Construction Division
Additions & Alteration Charges Approval Form

GULMOHAR RESIDENCY

Details of Additions & Alterations

Flat No	501	Block no.	H
Flat Area	sft	Type	Deluxe / Luxury
Buyer Name	Mr. Srva Rama Kashma		
Phone No.	9052 553616	Email

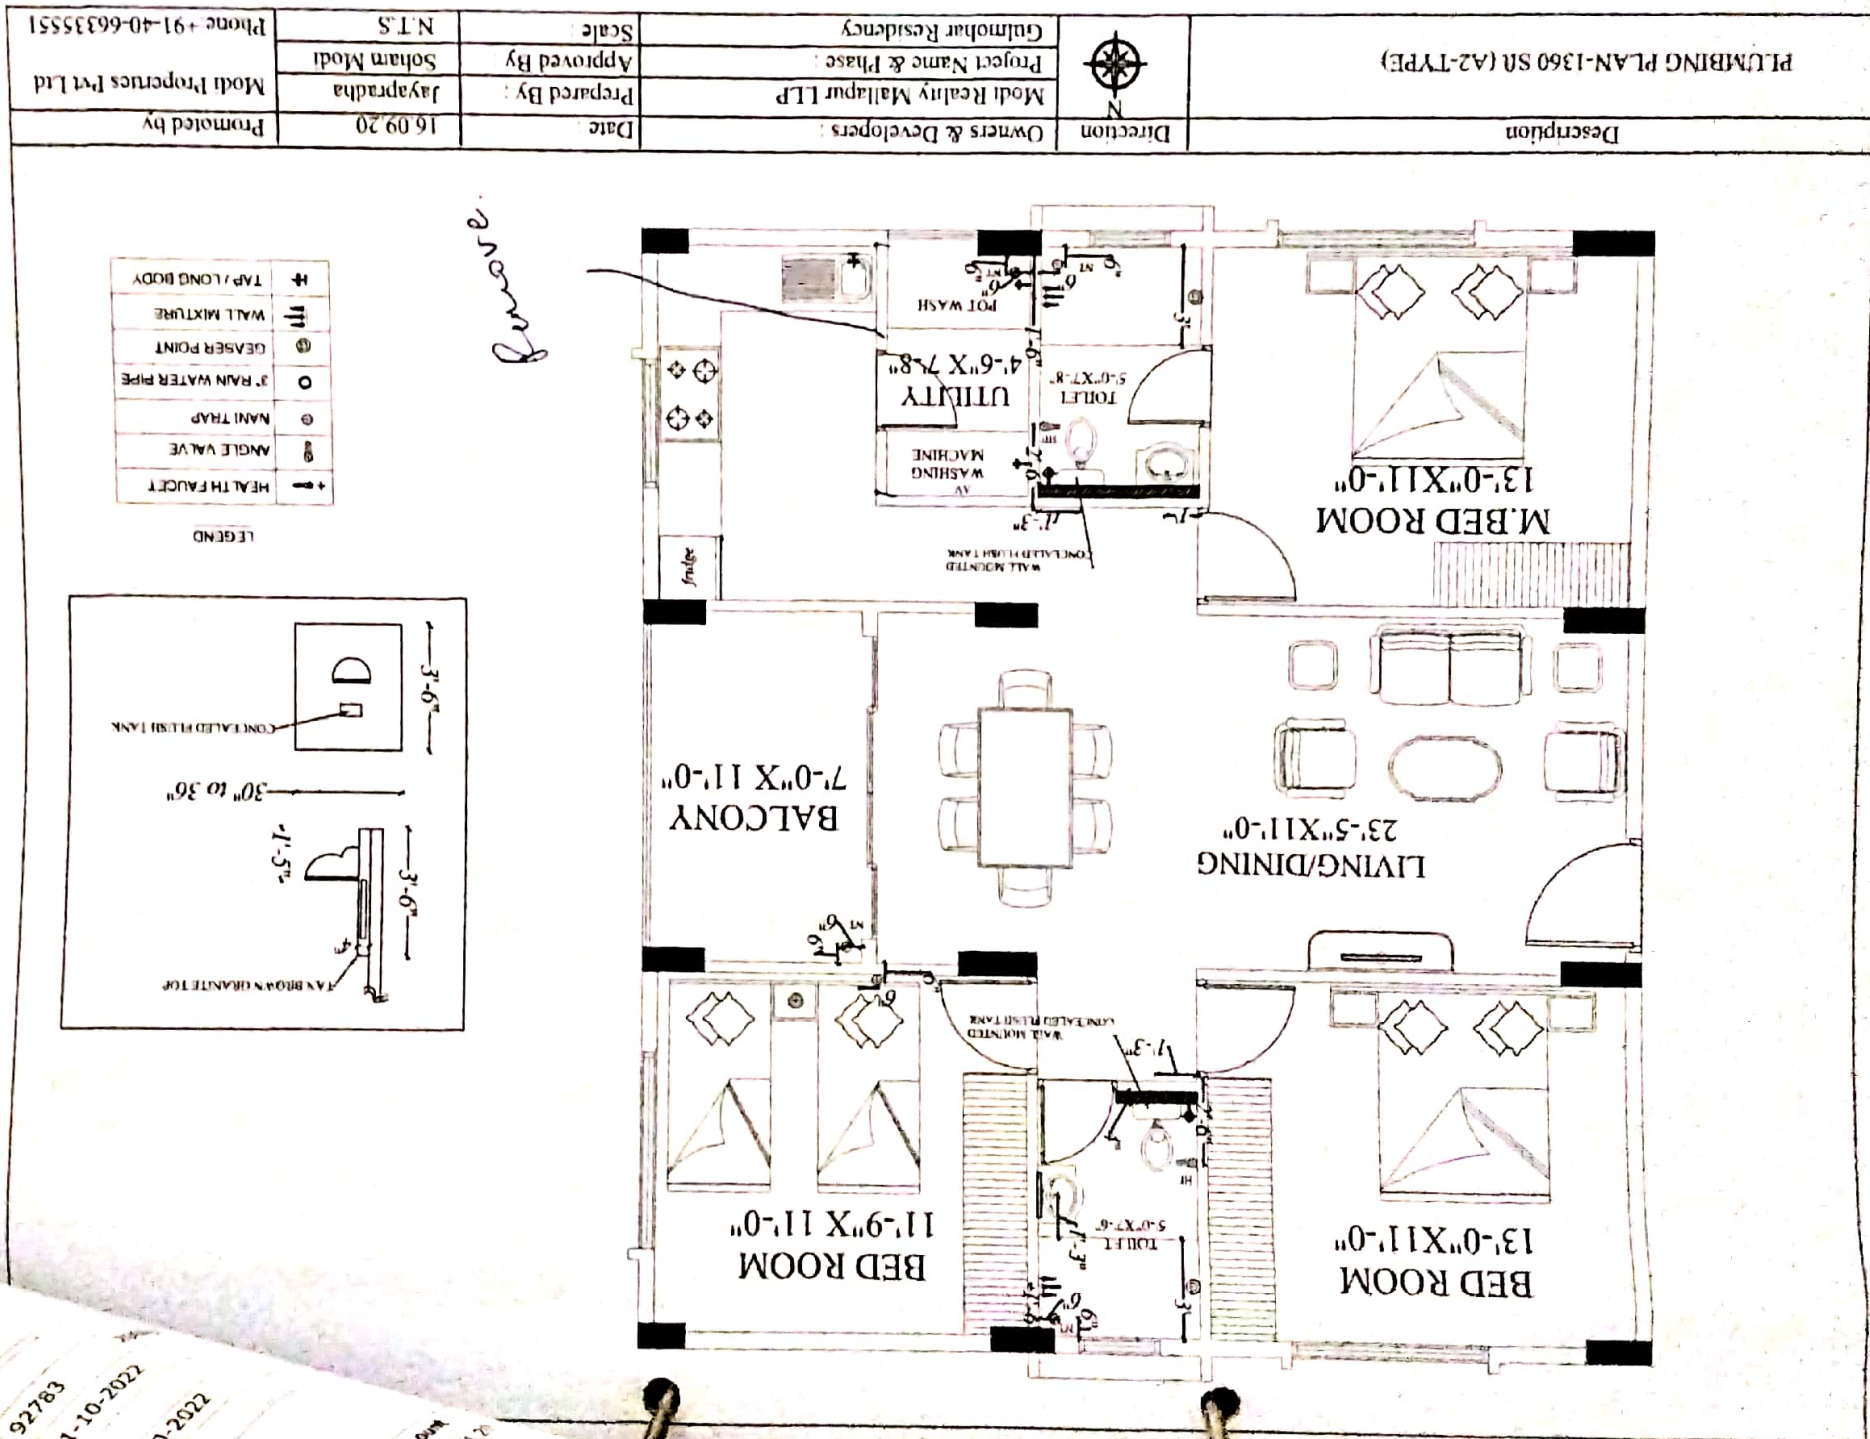
West side hall additional point for T.V
Common bathroom point to be changed
to hall beside bedroom.

AC point on hall at balcony hall partition
beam

Utility wall to be moved since inside to
that big kitchen & door to shifted to North
side

Common Bathroom to be turned into Master
attached bathroom to hall beside bedroom
and door to shifted to inside center with
electrical point.

25/7/23 wall to be removed at kitchen
no utility door to be removed
